**DEPARTMENT OF TRANSPORTATION
STATE OF GEORGIA**

SUBJECT APPROVED CONCEPT REPORT

**DEPARTMENT OF TRANSPORTATION
STATE OF GEORGIA
PROJECT CONCEPT REPORT**

SR 166/Duncan Memorial Highway @ SR 70/SR 92/SR 154/Campbellton Fairburn Road

GEORGIA DEPARTMENT OF TRANSPORTATION
DOUGLAS COUNTY
CAMPBELLTON FAIRBURN RD/ SR 70/ SR 154/ SR 92/ SR 166 AT
DUNCAN MEMORIAL HWY/ SR 166
P.I. NO. 0009835
CONCEPT LAYOUT

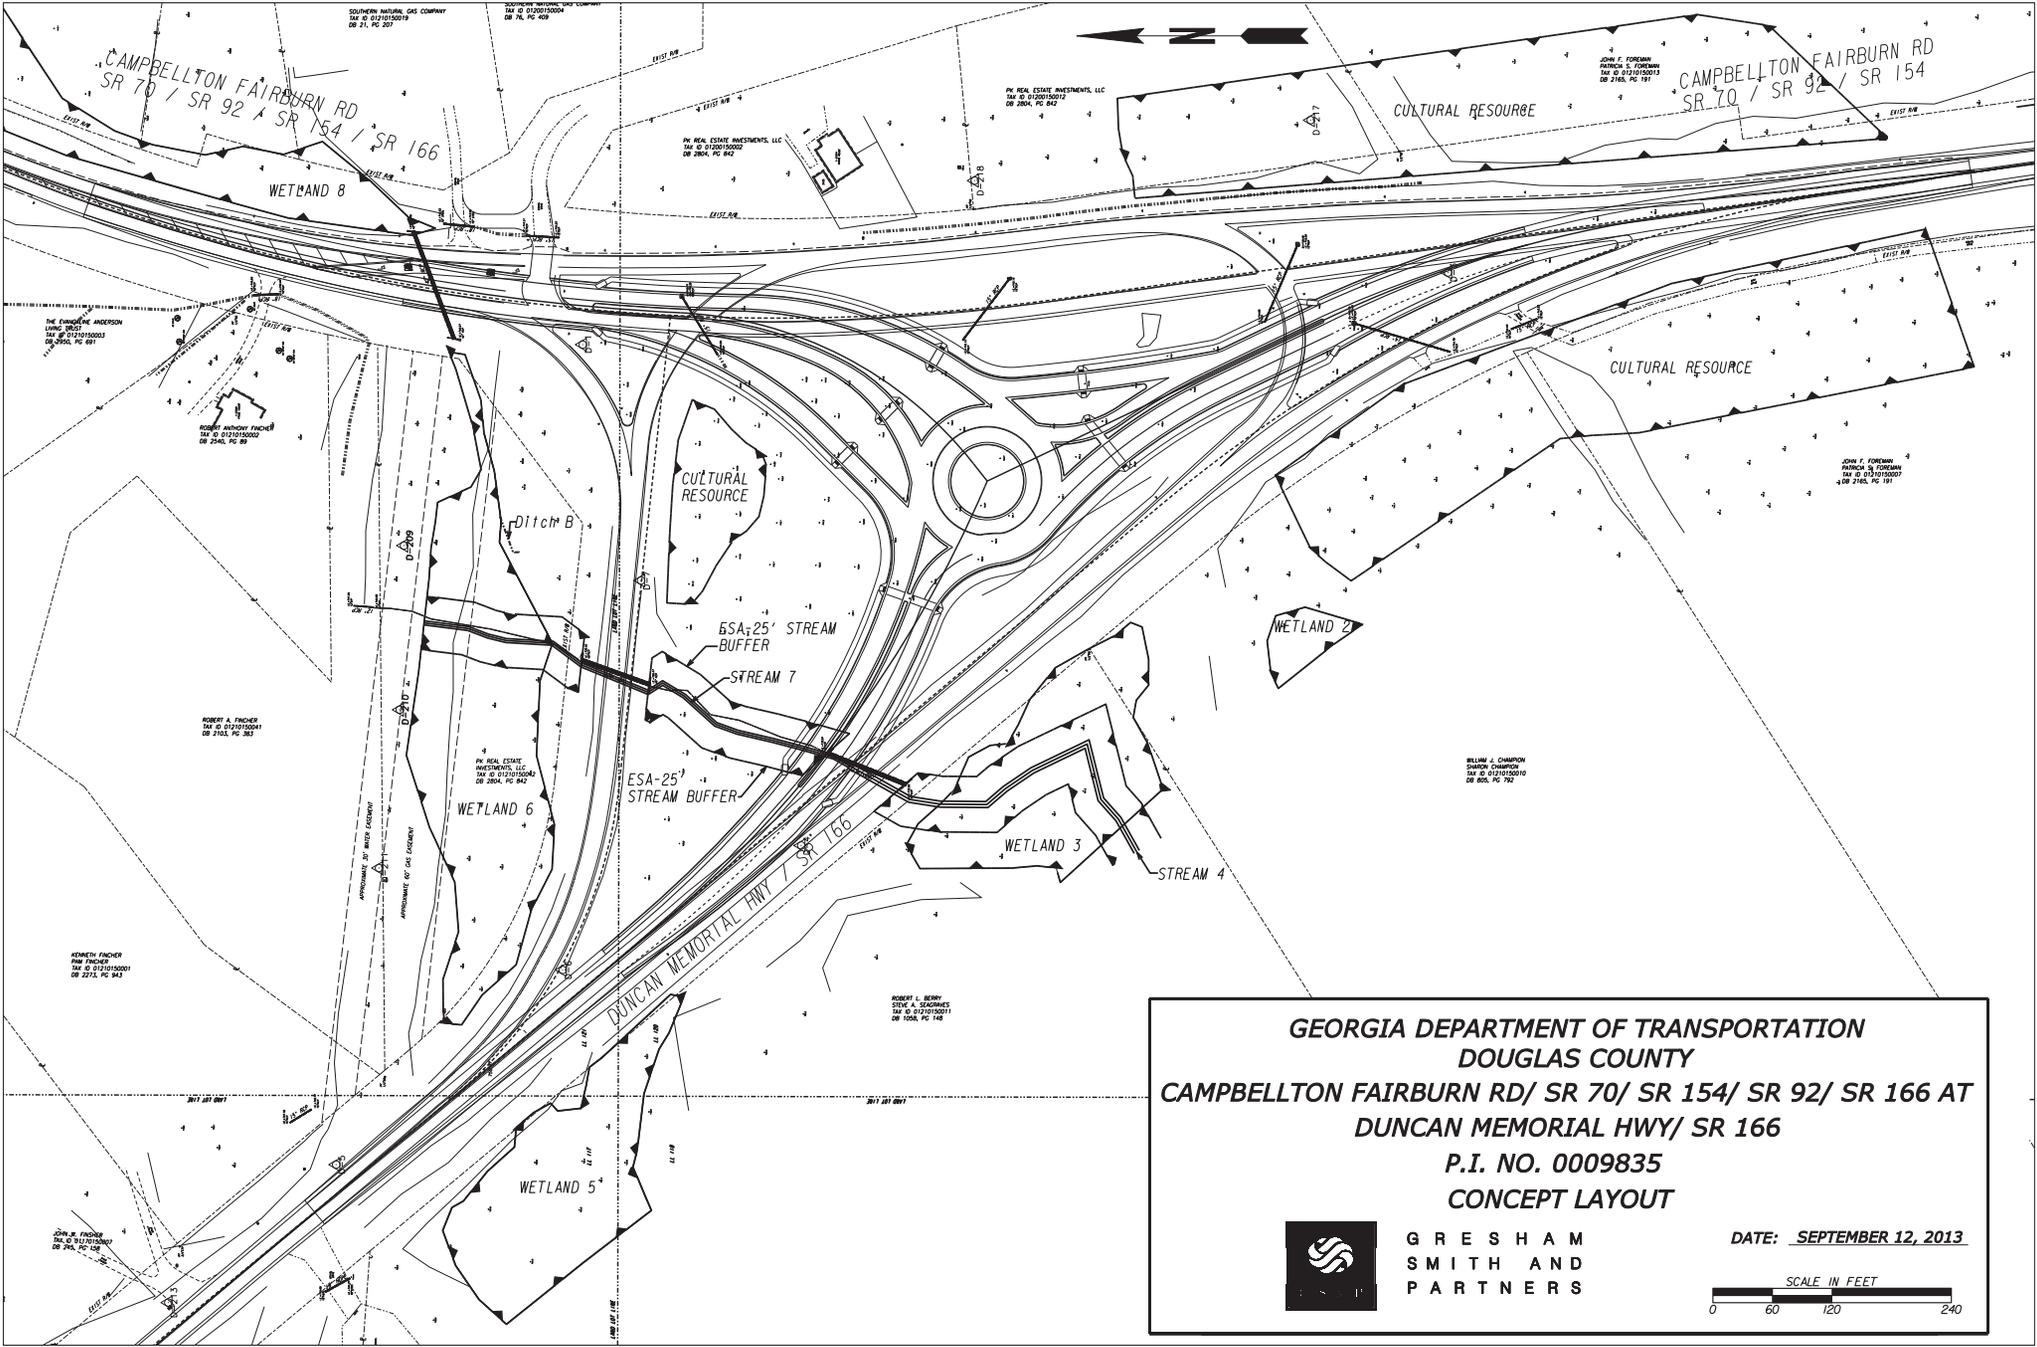
GDOT requested further analysis for vehicles traveling on the exit lanes of eastbound SR 166 onto and merging onto southbound SR 70/SR 92/SR 154. GS&P responded that they would review and verify that the traffic merging from eastbound SR 166 to southbound SR 70/SR 92/SR 154. GDOT also requested that the radius of the eastbound exit lanes be lengthened to provide additional length for vehicles merging onto SR 70/SR 92/SR 154. GS&P responded that the radius used in the concept was per direction of the peer review, which recommended that the use of tighter radii for bypass lanes results in vehicles exceeding design speeds through the bypass lane.

GDOT recommended that the proposed type 7 curb and gutter in the design data table for the inside shoulders be changed to type 7 header curb. GS&P agreed to make the design change. GDOT recommended that the minimum splitter island width should be changed from 2 feet to 4 feet, GS&P agreed.

GDOT stated that the estimated construction time could be reduced from 18 months to 12 to 15 months because of the flat topography. GDOT also stated that the bicycle lanes will require transition to the travel lanes instead of terminating to paved shoulder as shown in the concept. GS&P responded that the bicycle lanes can be revised to include tapering to the travel lanes. GDOT stated that all roadway sections with a width less than 2 feet from back of curb to sidewalk will require a design variance. GS&P responded that those sections will be reviewed to determine if the width can be increased to 2 feet.

After reviewing the CES concept cost estimate, GDOT requested the addition of the colored Class A Concrete quantity for the concrete truck apron. GDOT also requested the TP IX reflective sign sheeting quantity to be increased from 900 sf to 1000 sf to provide enough material for all diagrammatic and warning signs, as well as the addition of landscaping quantities that follow GDOT details RA-1 and RA-2. It was recommended that the GDOT project manager contact Douglas County for landscaping plans. GDOT also requested that the type 7 curb and gutter quantity be changed to type 7 header curb. GS&P agreed to all of the quantity changes requested.

GDOT recommended that the location of the advance warning sign for the roundabout located on the northbound approach of SR 70/SR 92/SR 154 will require placement that is less than the recommended minimum spacing of 1,500 feet from the roundabout approach yield lines due to the location of a bridge crossing the Chattahoochee River being located 1,100 feet from the roundabout approach. GDOT recommended placement of the signs to avoid the bridge in order to prevent an environmental re-evaluation. The GDOT project manager will provide GS&P direction on sign placement in the preliminary design phase.

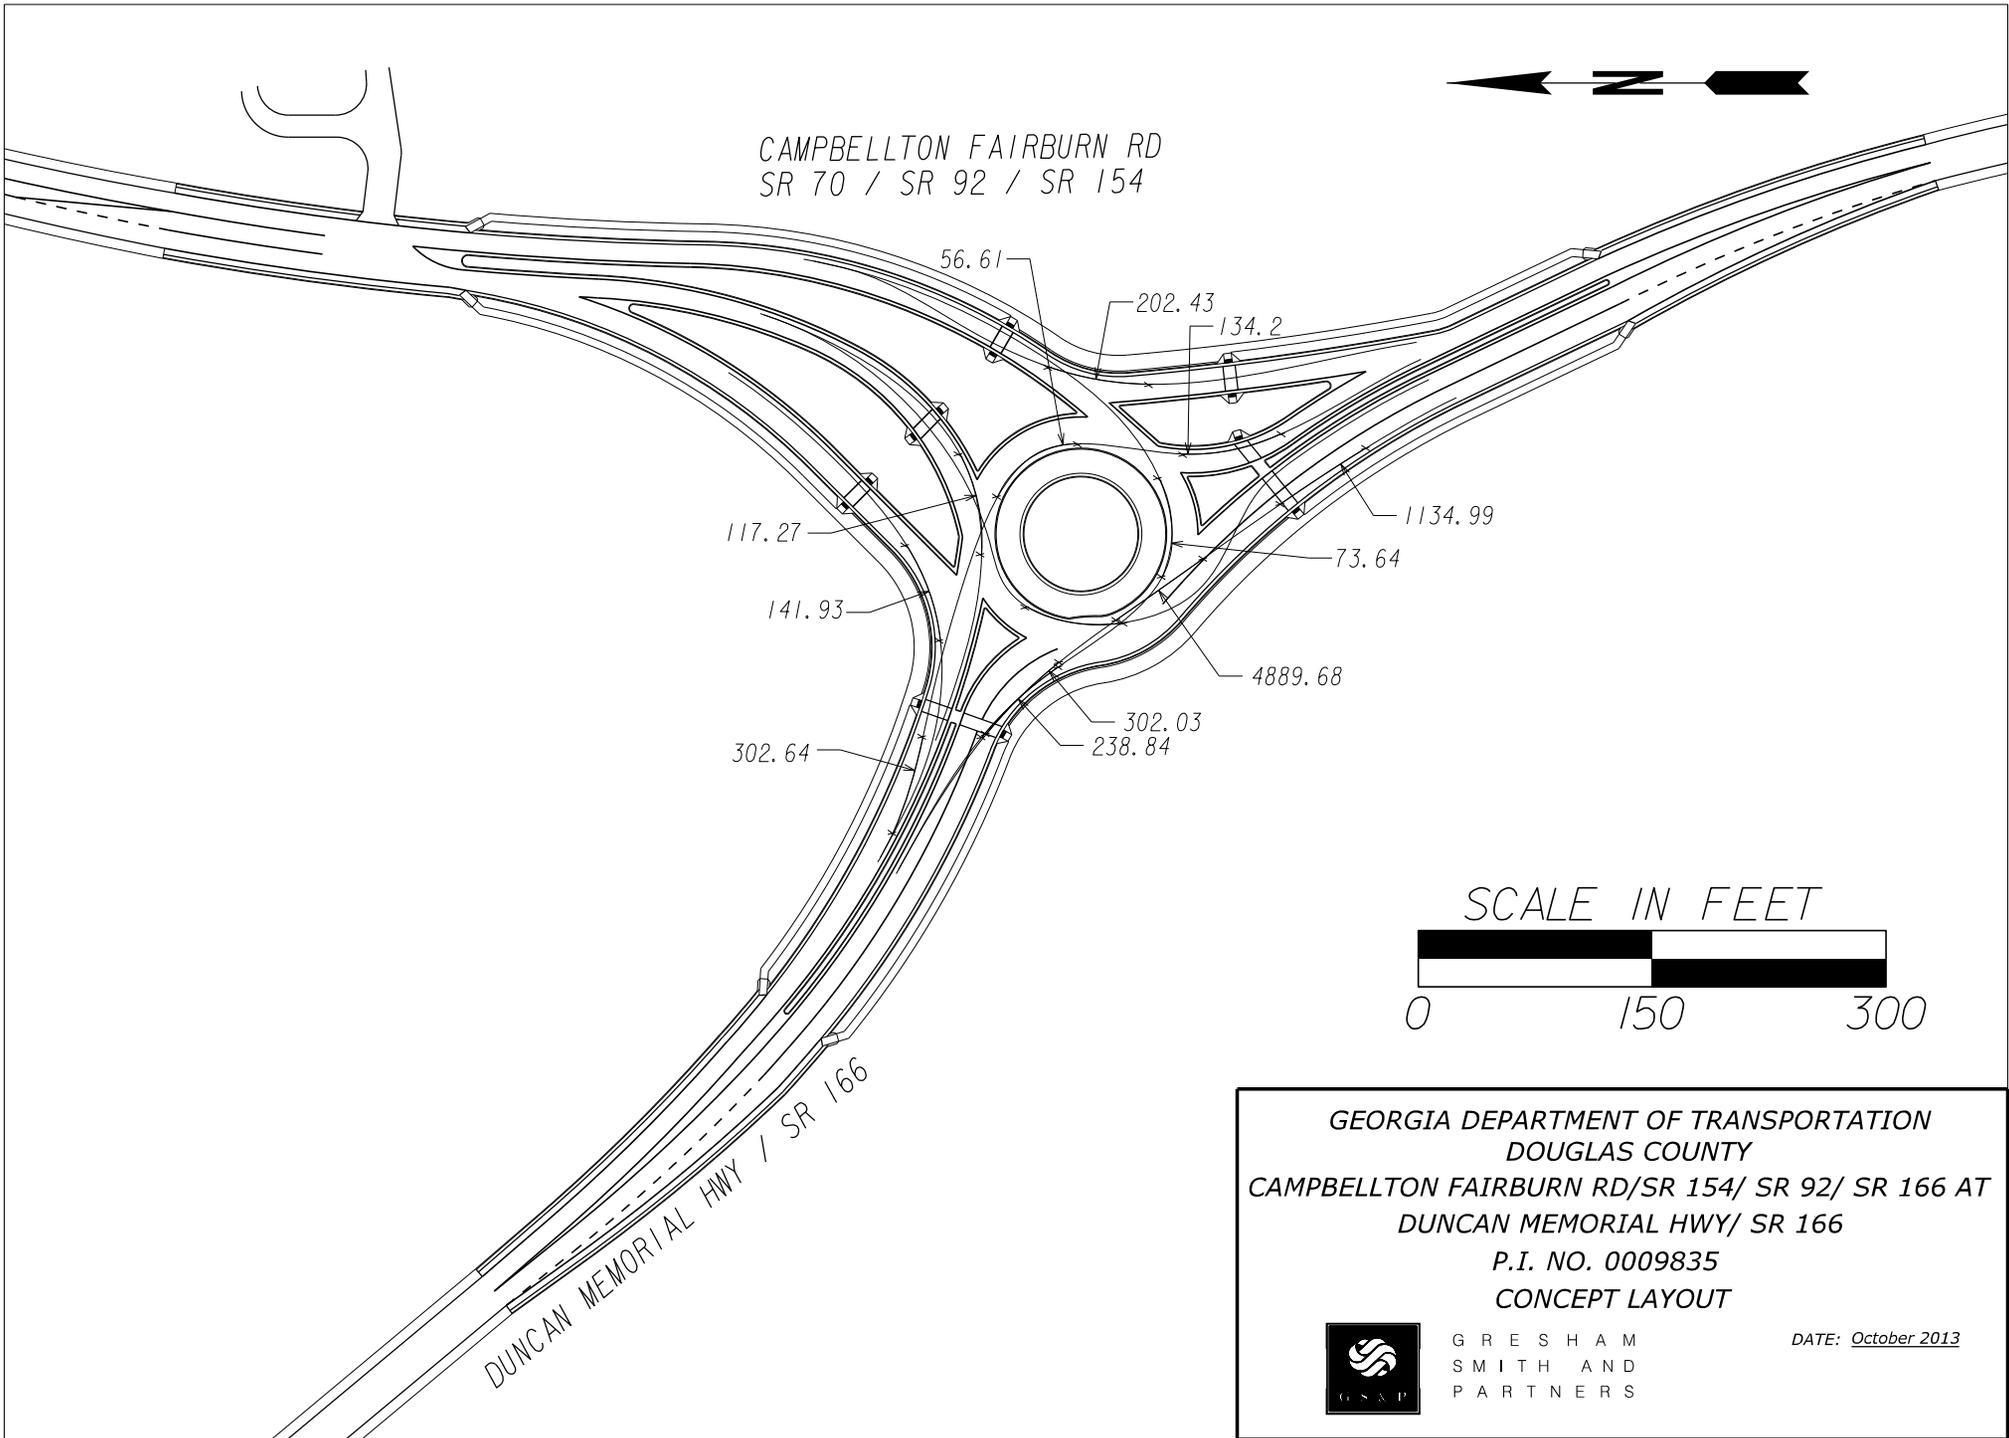
- Lane configuration is not correct
4. Comments regarding Alternative #3:
 - Lane configuration is not correct
 - Circle location could be adjusted to improve the angles of entry

5. Comments regarding Alternative #4:
 - Circle location does not provide optimum roundabout geometry
 - Lane configuration is incorrect
 - Oval shape is not necessary

7. GSP will explore the circle location shift that was suggested. Also approach alignment modifications will be explored to incorporate the revised circle location. GSP
